PEACH BOTTOM ATOMIC POWER STATION, UNIT NO. 2

AMENDMENT TO FACILITY OPERATING LICENSE

Amendment No. # 4
License No. DPR-44

(CHANGE NO. 6 TO THE TECHNICAL SPECIFICATIONS)

I. Average Planar LHGR

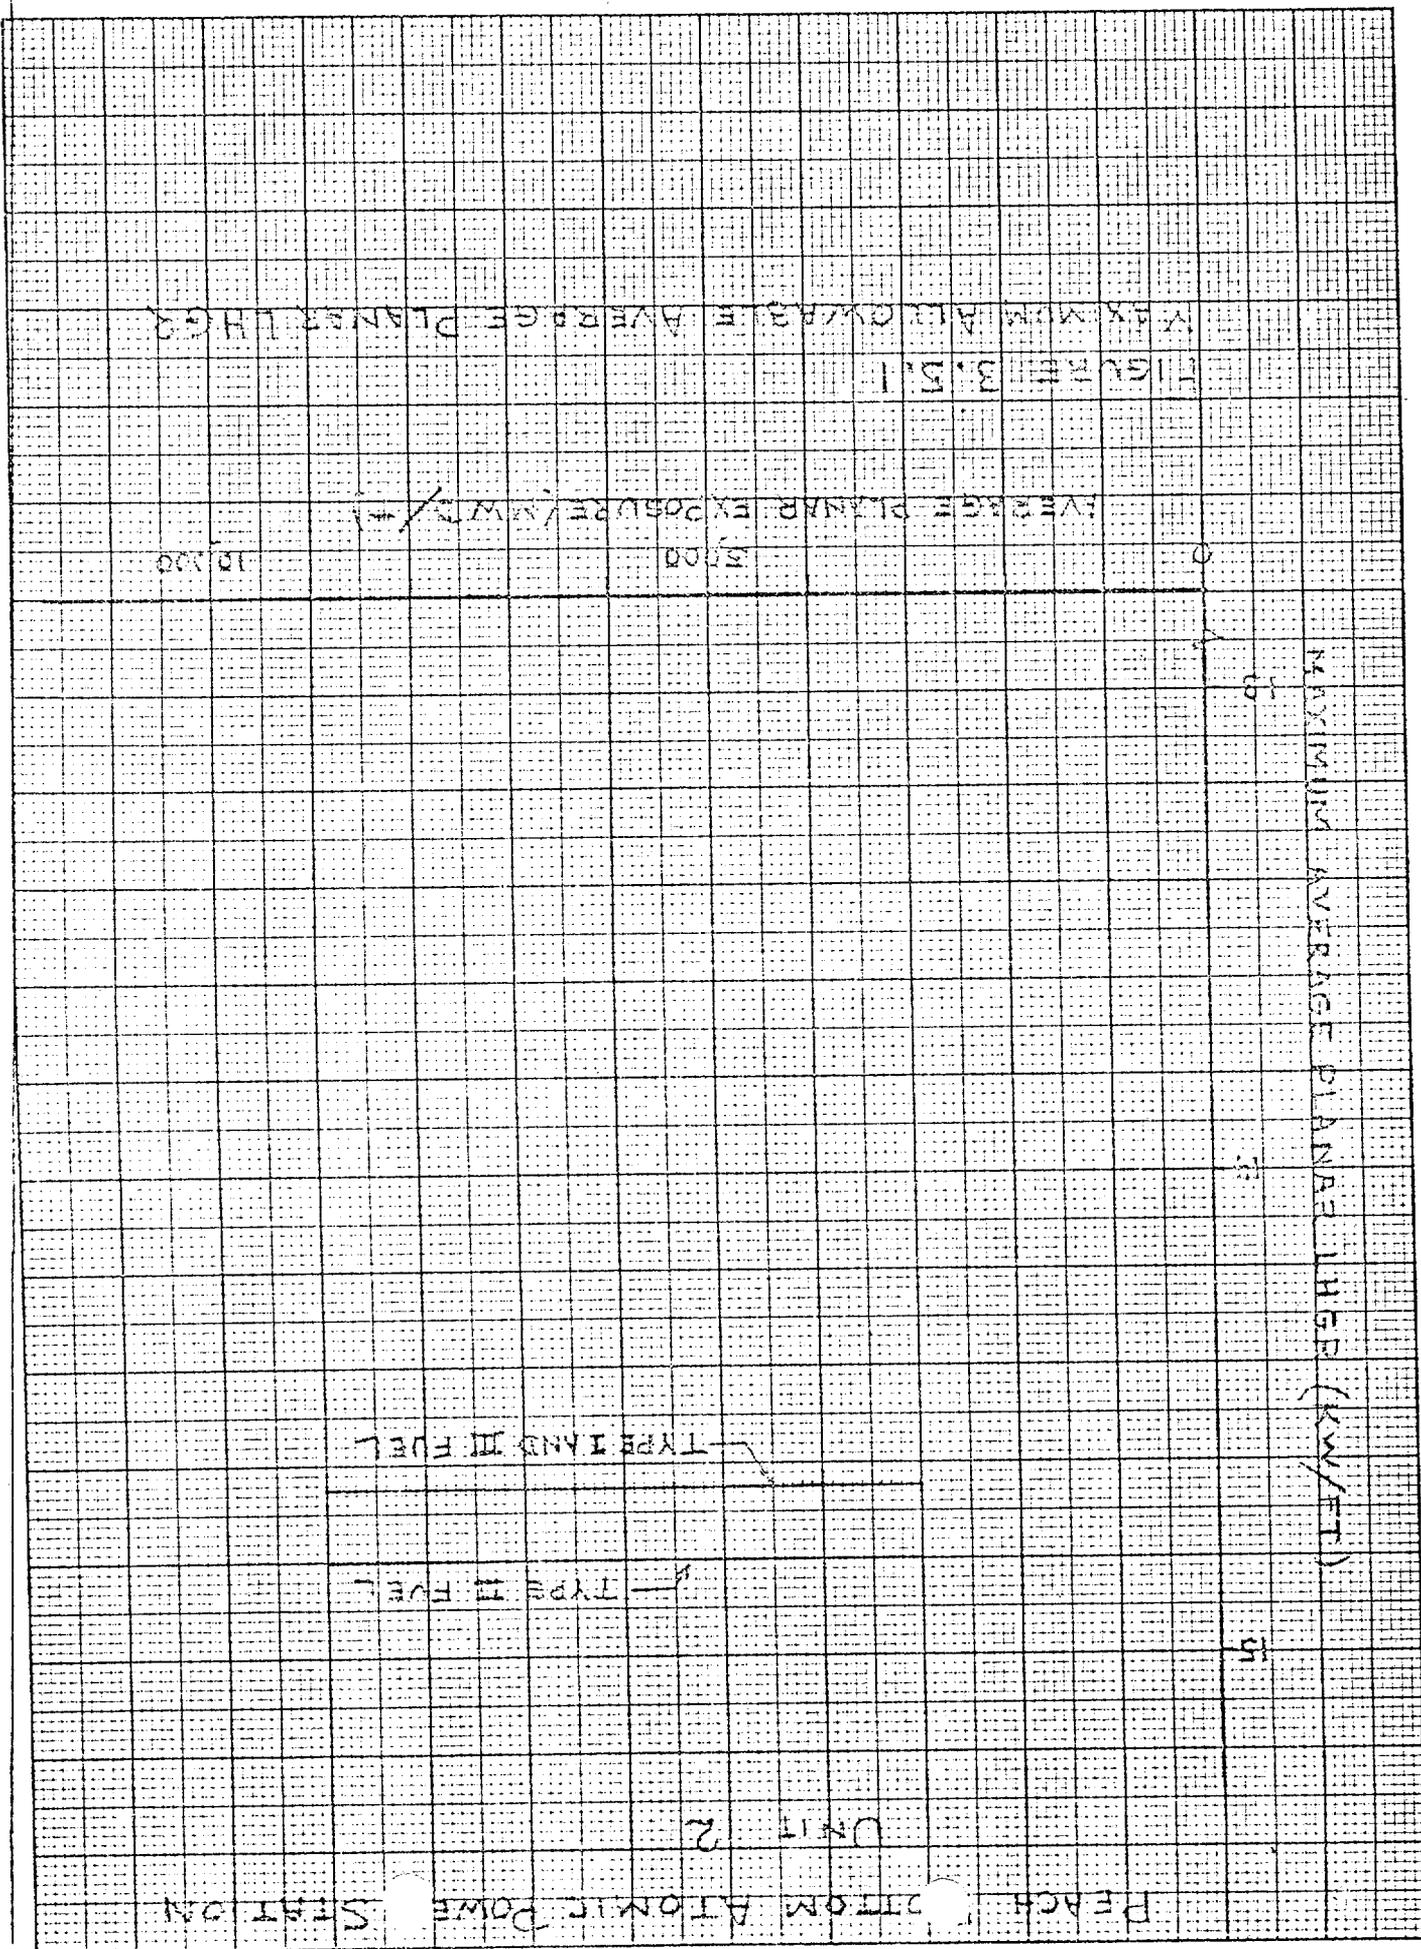
During steady state power operation, up to an average planar exposure of 9000 MWD/T, the average linear heat generation rate (LHGR) of all the rods in any fuel assembly, as a function of average planar exposure, at any axial location, shall not exceed the maximum average planar LHGR shown in Figure 3.5.1.A.*

The 2300°F peak clad temperature of these curves (Figure 3.5.1.A of the revised Technical Specifications) maintain the Interim Acceptance Criteria (IAC) during a loss-of-coolant accident (LOCA) while allowing steady state power operation at higher average planar linear heat generation rates.

The amendment permits operation with revised maximum average planar linear heat generation rate curves up to an average planar exposure of 9000 MWD/T.

The staff's current calculation modifies the previously performed calculation by incorporating pellet densification based on actual fuel burnup and a reasonable gap closure due to pellet cracking and relocation. Of the two effects gap closure is the dominant effect. For constant operating conditions, the consideration of fuel pellet-clad gap closure increases the calculated thermal conductance for the gap, reduces the calculated fuel pellet stored energy and reduces the calculated peak clad temperature following a LOCA. Conversely for a constant calculated post-LOCA peak clad temperature the MAPLHGR can be increased when gap closure due to pellet cracking and relocation is considered.
